ADDENDUM NO. 002 (Rev 01/2017)

ISSUE DATE: **03/12/2024**

RE: **GRAINGER HALL 2ND & 5TH FLOOR RENOVATION
PHASE 2 - 5TH FLOOR OFFICE RENOVATION &
PHASE 3 - 2ND FLOOR NW CORNER RENOVATION
UNIVERSITY OF WISCONSIN-MADISON
610 WALNUT STREET
MADISON, WISCONSIN**

UWSA Project No. **A-22-021**
UW Madison Project No. **0140-2303**

1 5TH FLOOR NEW WORK PLAN - ELECTRICAL SYSTEMS
 SCALE: 3/16" = 1'-0"
 12' 0" 1' 8" 16"

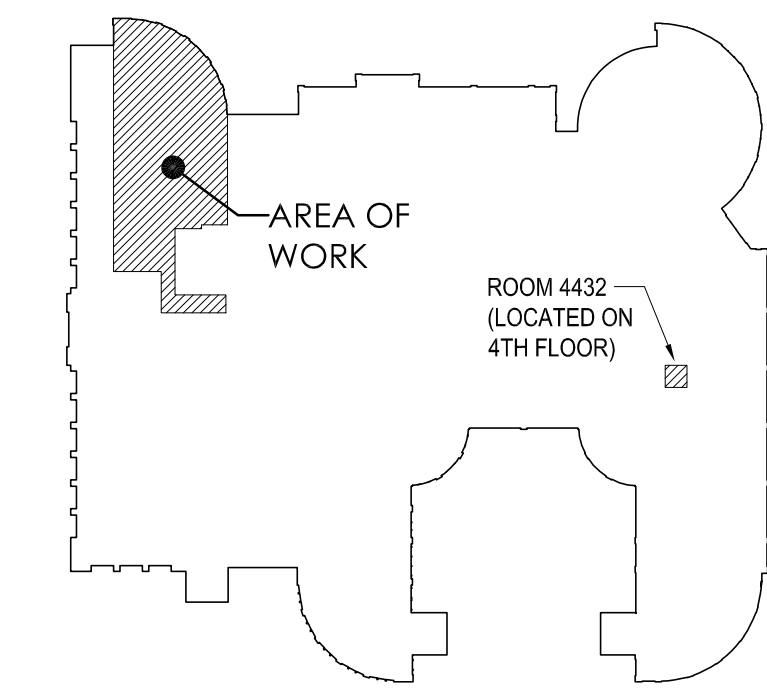
- i. **REVISE:** General Note 2. Correct spelling of "APPLIFIERS" to AMPLIFIERS. Then add the following after the period: PROVIDE SHOP DRAWINGS INDICATING CODE-COMPLIANT PLACEMENT OF NEW SPEAKERS, STROBES, PULL STATIONS AND OTHER REQUIRED DEVICES. See Sheet ES101.

- REUSE FIRE ALARM AUDIO CIRCUITS TO THE EXTENT POSSIBLE. PROVIDE NEW AUDIO CIRCUITS AND CABLING FROM EXISTING FAC. ASSUME NEW AMPLIFIERS ARE REQUIRED. PROVIDE SHOP DRAWINGS INDICATING CODE-COMPLIANT PLACEMENT OF NEW SPEAKERS, STROGES, PULL STATIONS AND OTHER REQUIRED DEVICES.

Graphic Scale	NTS
PRJ. Number	UW: MSN 0140-2303
UWSA: A-22-021	
Set Type	BD
Date Issued	02/20/2024
Sheet Number	E401

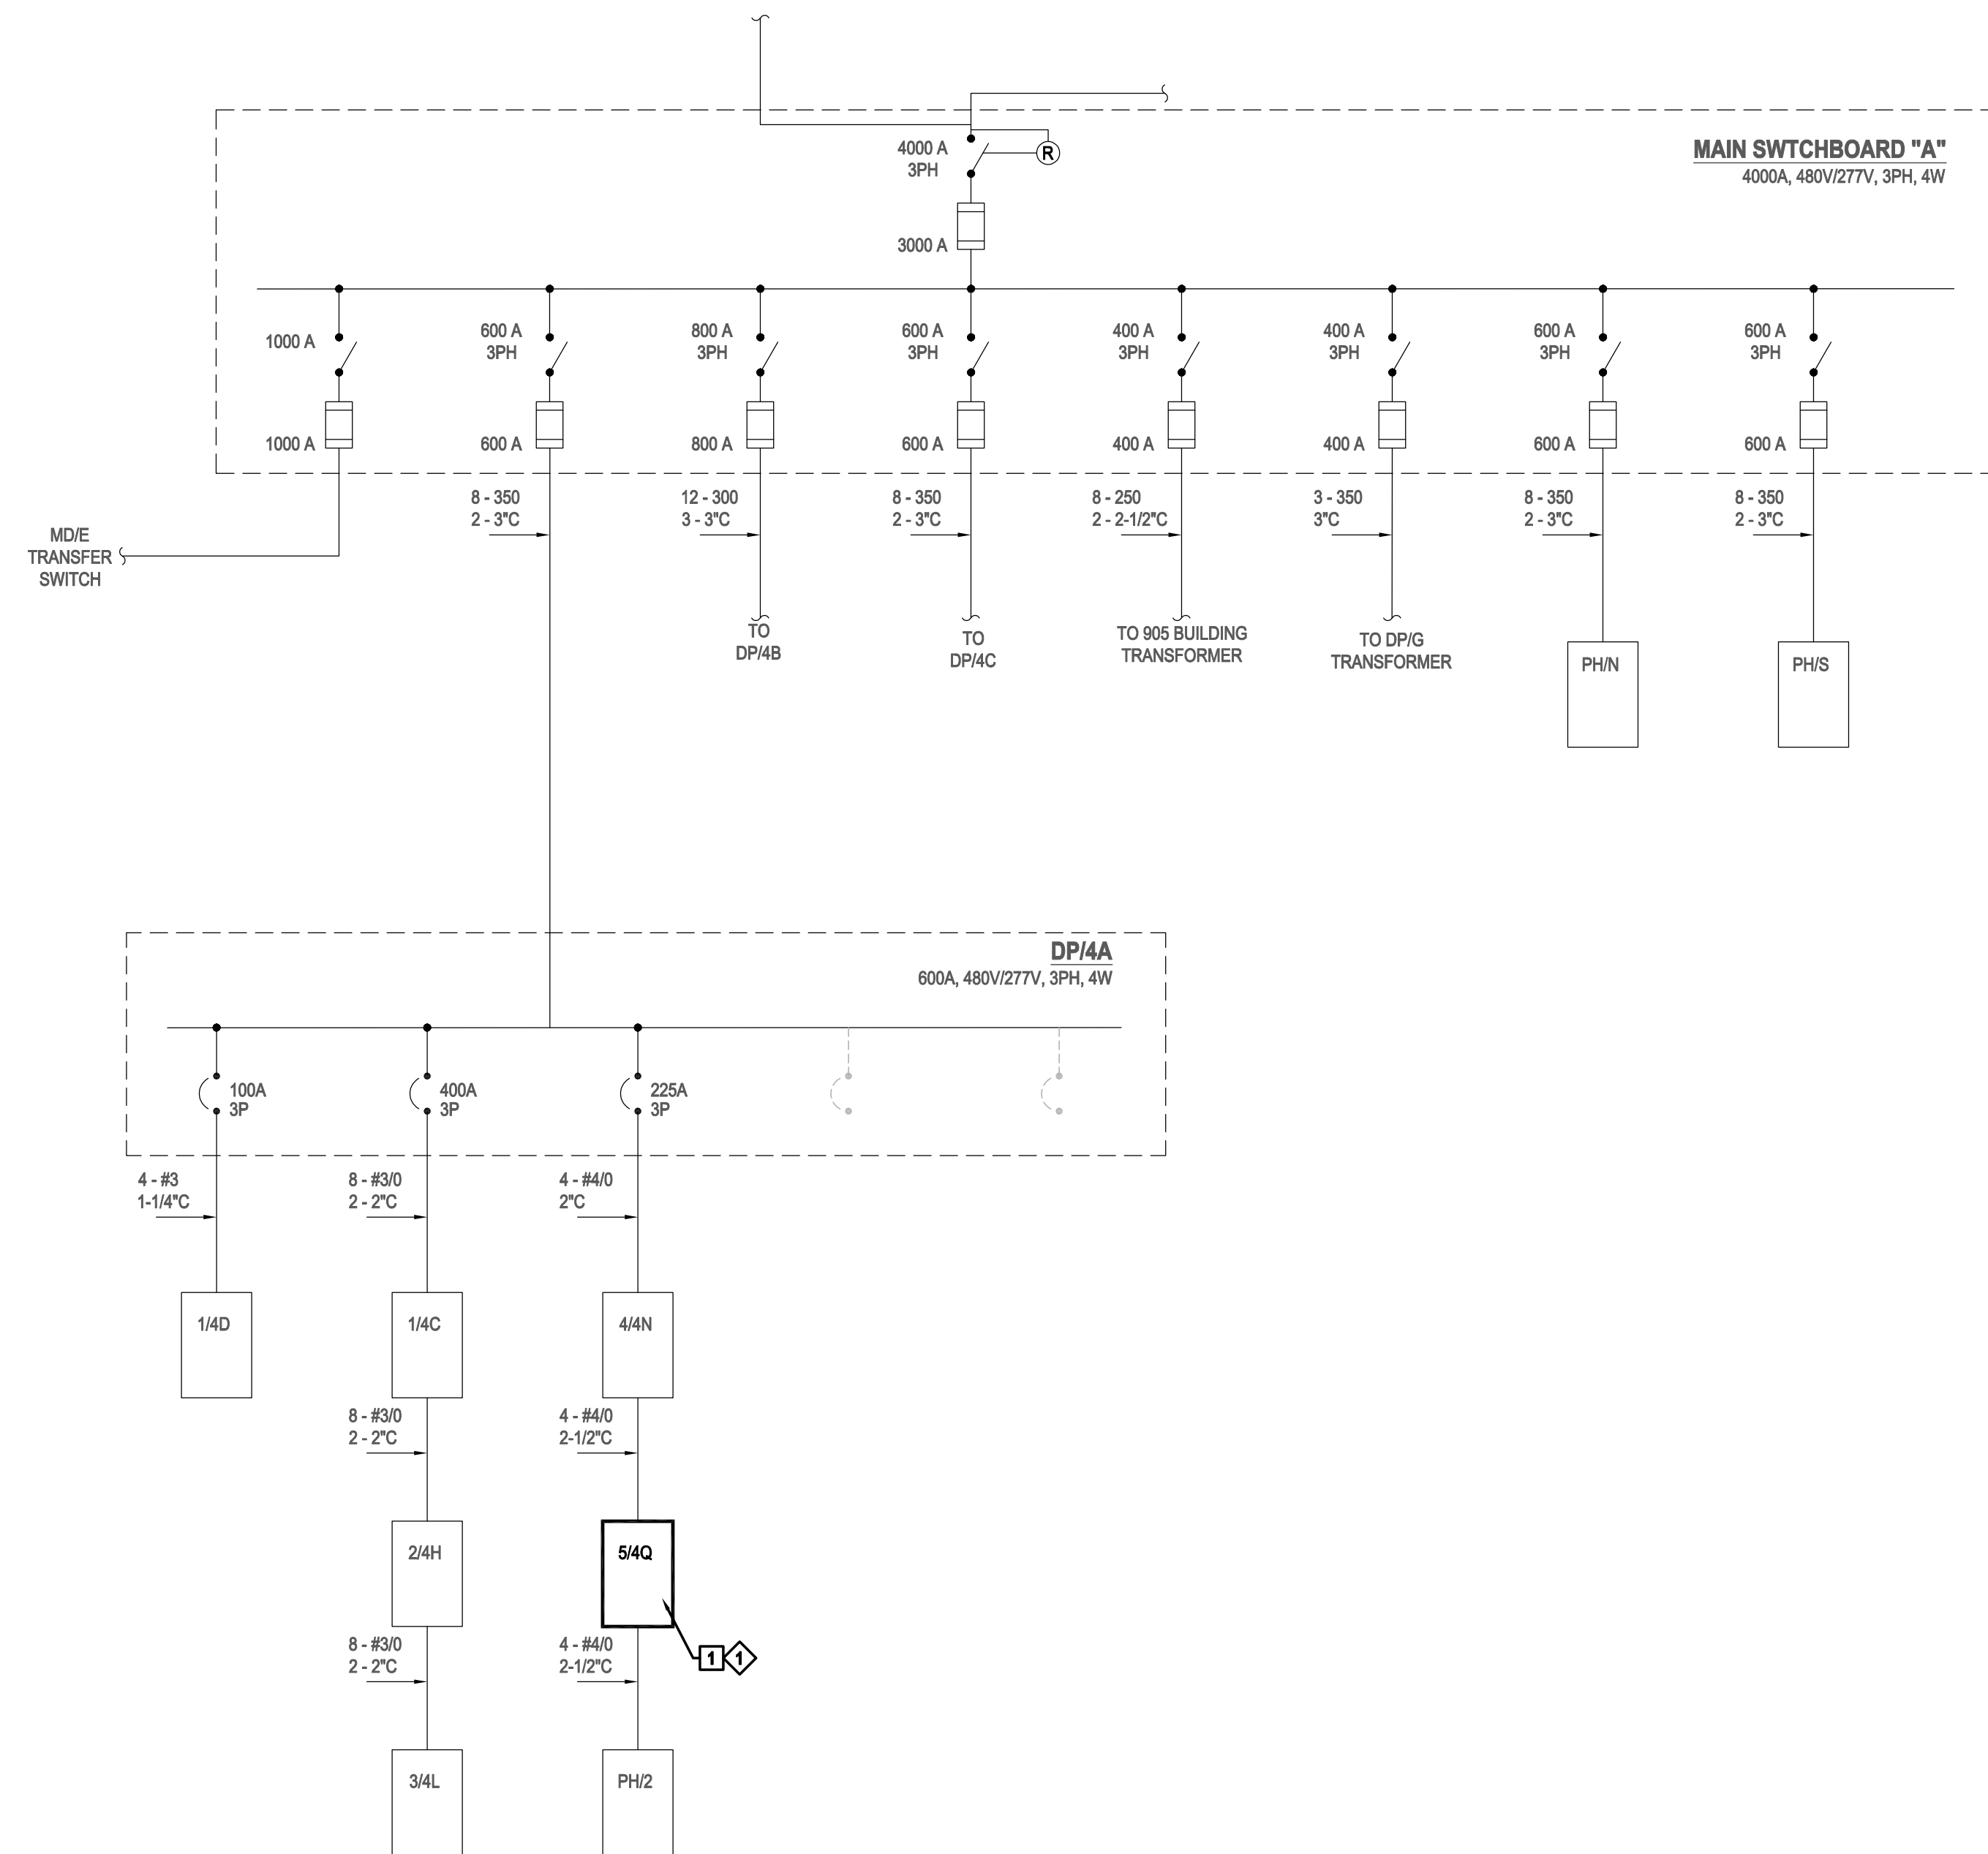
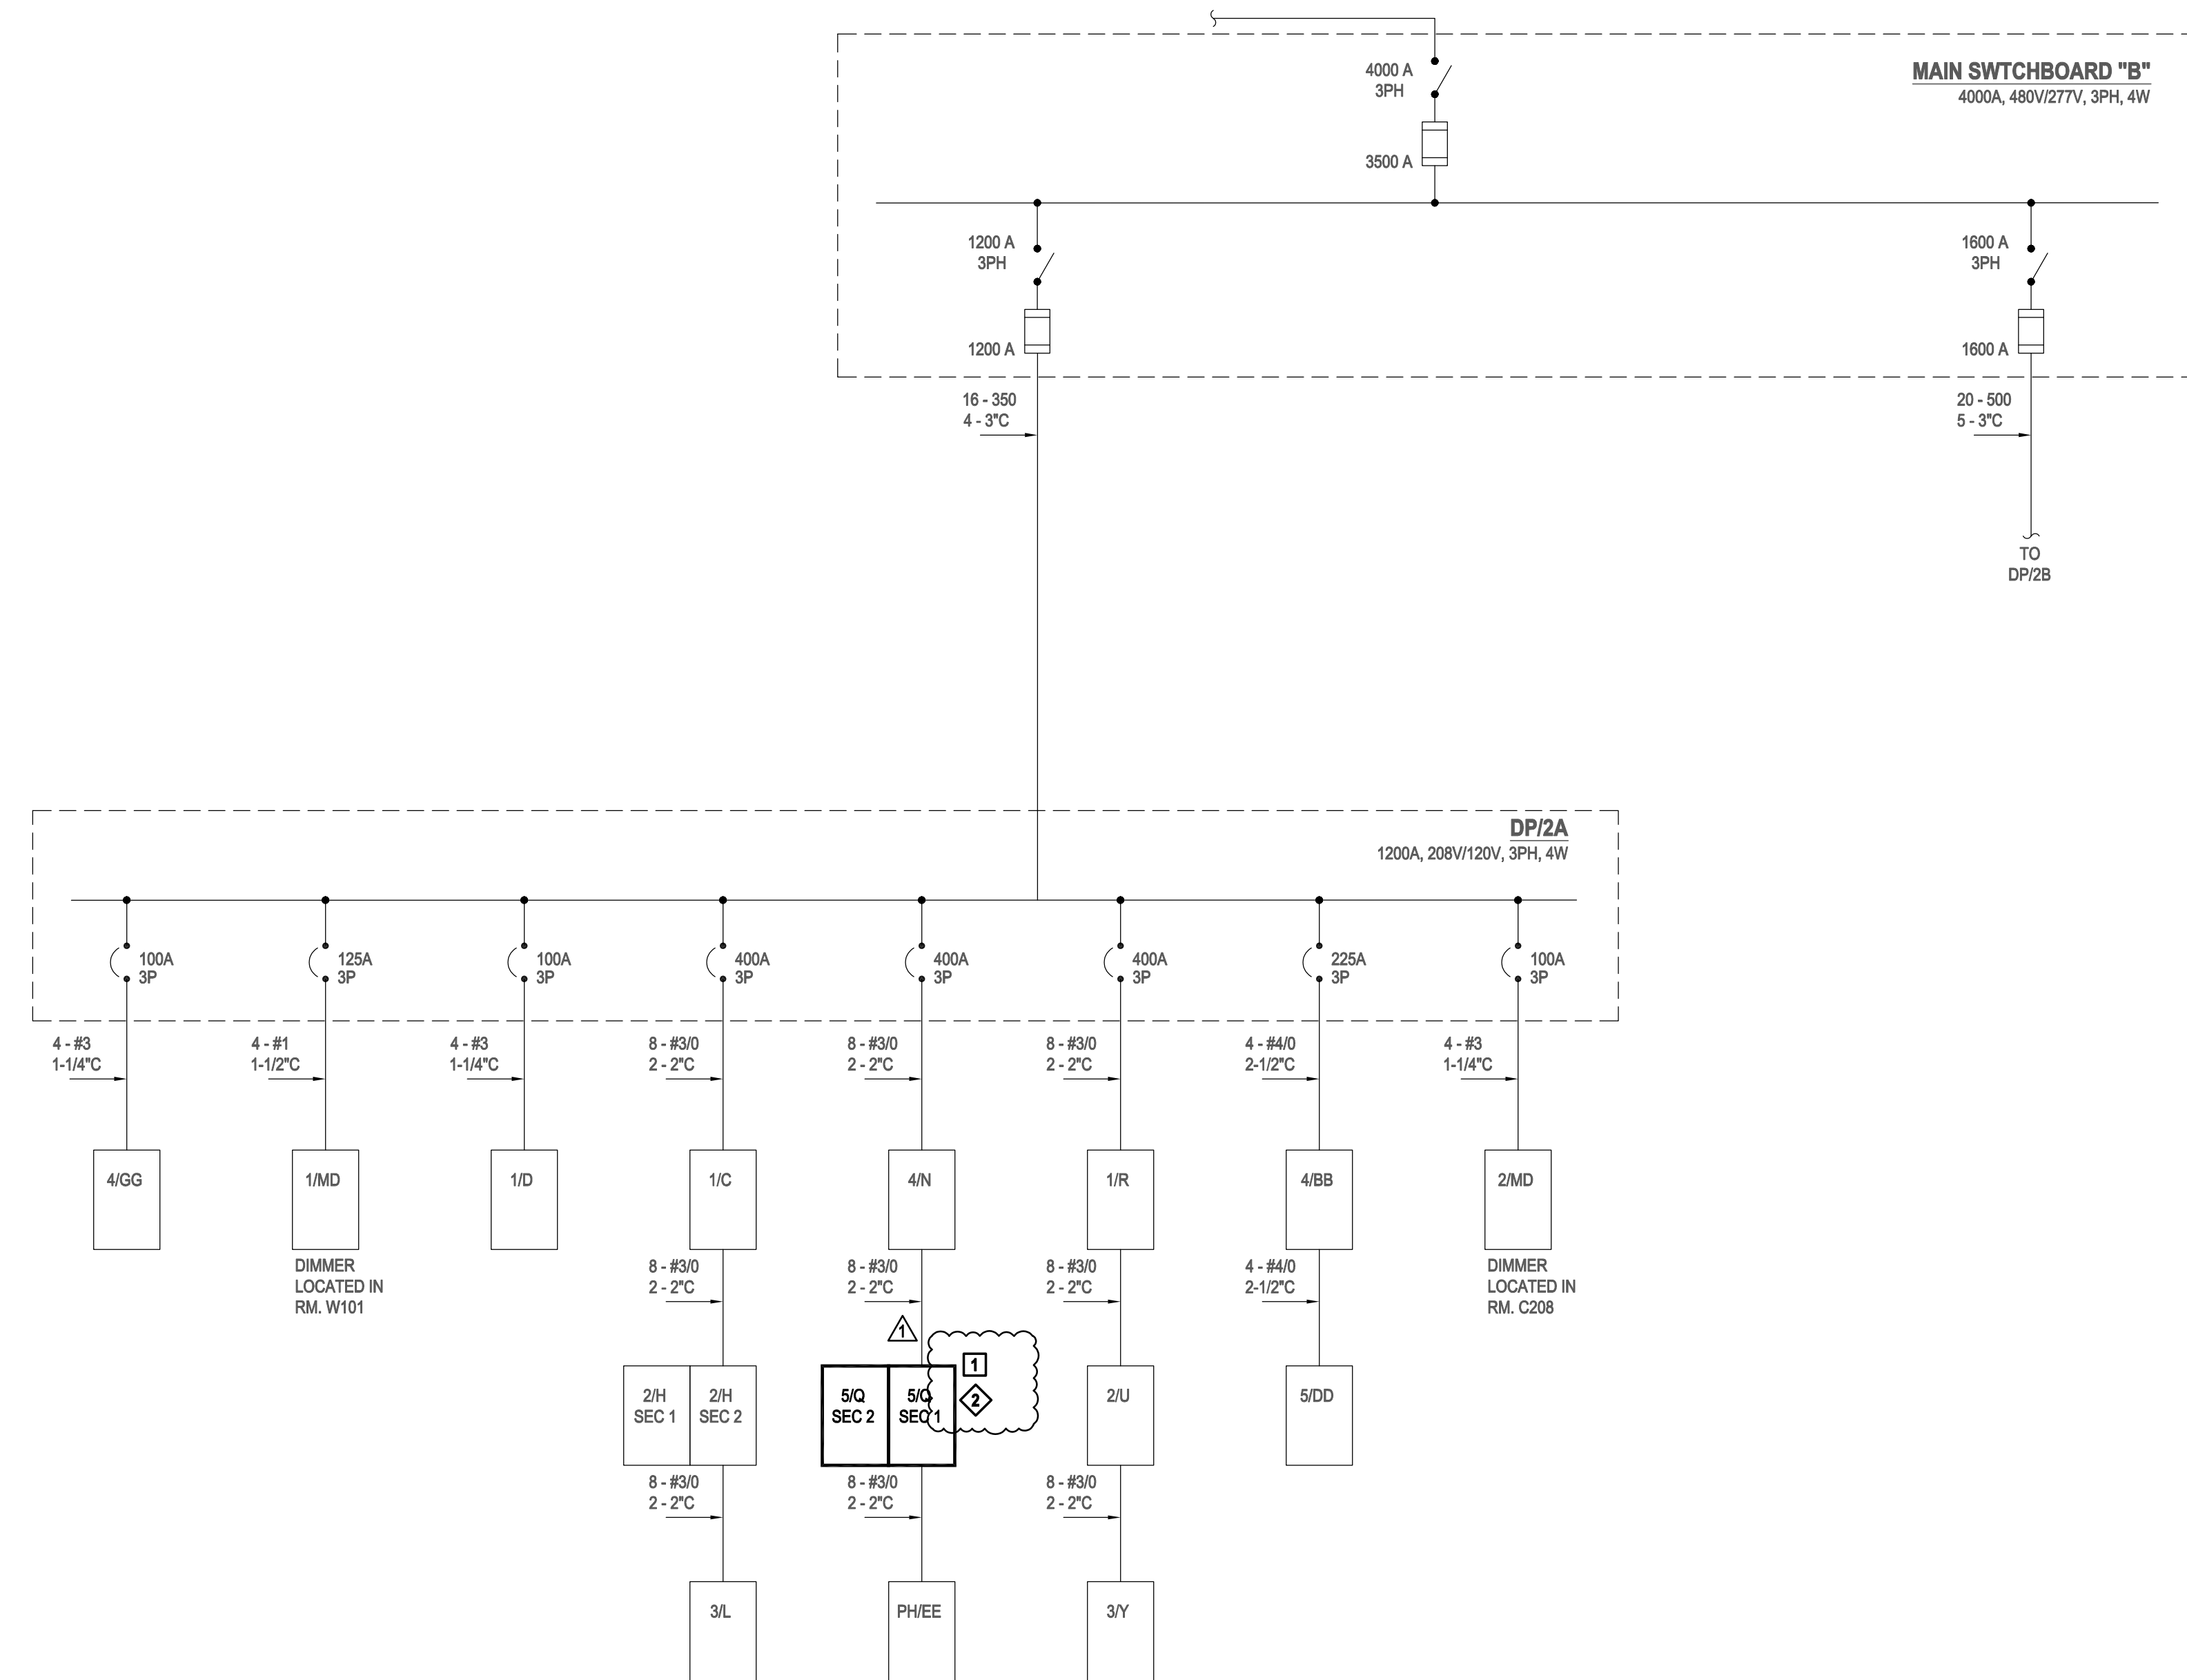
- c. Sheet E401
 - i. **REVISED:** Keyed Demolition Note 1. Note change to REMOVE AND REPLACE BUS AND BREAKERS TO REDUCE ARC FLASH PROTECTION REQUIREMENTS, COORDINATE WITH ONWER FOR OUTAGE SCHEDULE. See Sheet E401.

- ii. **ADD:** Keyed New Work Notes. Add keynote 2, INSTALL PANEL BUS AND BREAKERS TO REDUCE ARC FLASH PROTECTION REQUIRMENTS. PROVIDE 14KA AIC RATING FOR PANEL. COORDINATE WITH OWNER FOR OUTAGE SCHEUDLE. See sheet E401.

- REMOVE AND REPLACE PANEL BUS AND BREAKERS TO REDUCE ARC FLASH PROTECTION REQUIREMENTS. COORDINATE WITH OWNER FOR OUTAGE SCHEDULE.

- INSTALL PANEL BUS AND BREAKERS TO REDUCE ARC FLASH PROTECTION REQUIREMENTS. PROVIDE 22KA AIC RATING FOR PANEL. COORDINATE WITH OWNER FOR OUTAGE SCHEDULE.
- INSTALL PANEL BUS AND BREAKERS TO REDUCE ARC FLASH PROTECTION REQUIREMENTS. PROVIDE 14KA AIC RATING FOR PANEL. COORDINATE WITH OWNER FOR OUTAGE SCHEDULE.
